Meath County Council

09/02/2024

Re: Ballivor Wind Farm ABP-316212-23 – MCC's Comments on Significant Additional Information

Fig. 1: Cumulative Context Update (Source: Response to Observations Received)

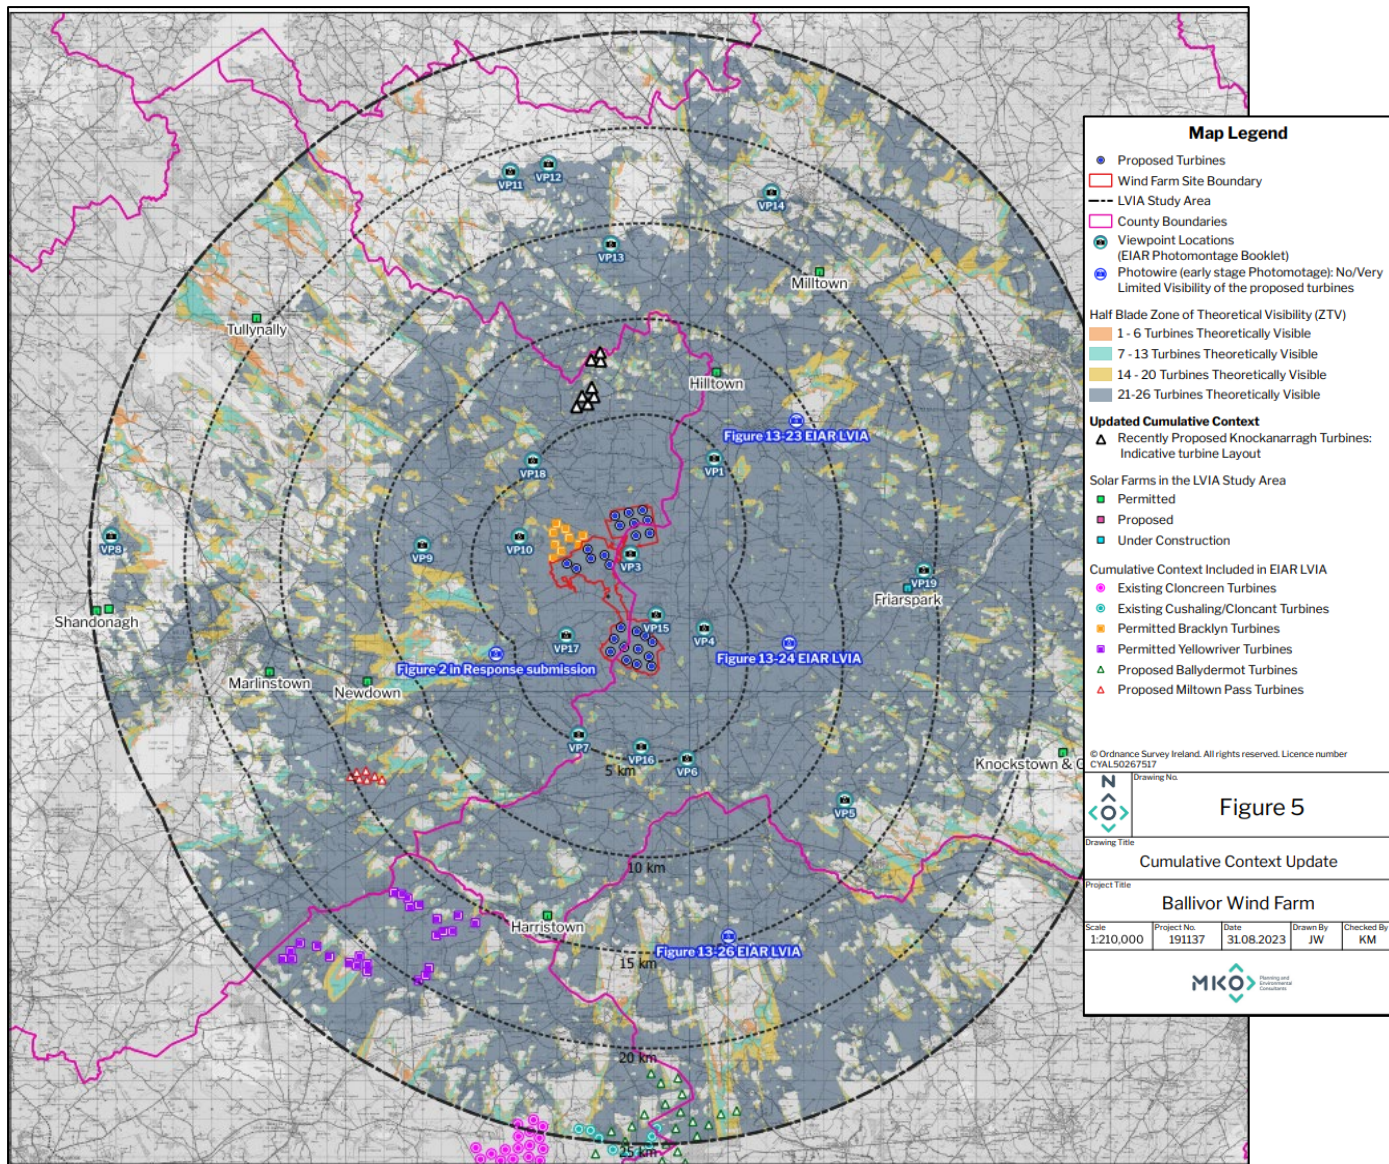
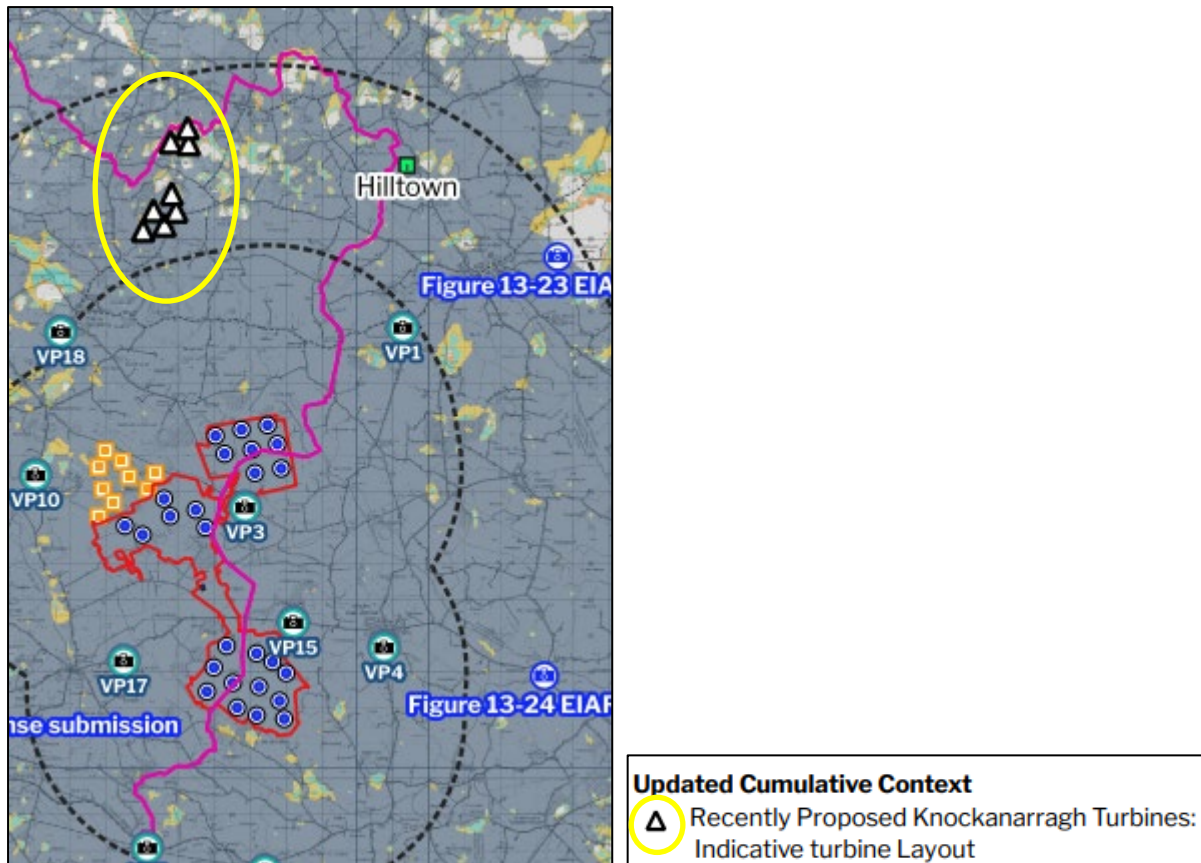
The location of all nearby existing, permitted and proposed wind turbines was updated and presented on the following Zone of Theoretical Visibility map, submitted with the applicant's 'Response to Observations Received'. The applicant has included a colour coding (not available in the EIAR submitted for the SID application) and it illustrates the likely visibility of turbines within a 25km radius of the proposed development (see Figure 1).
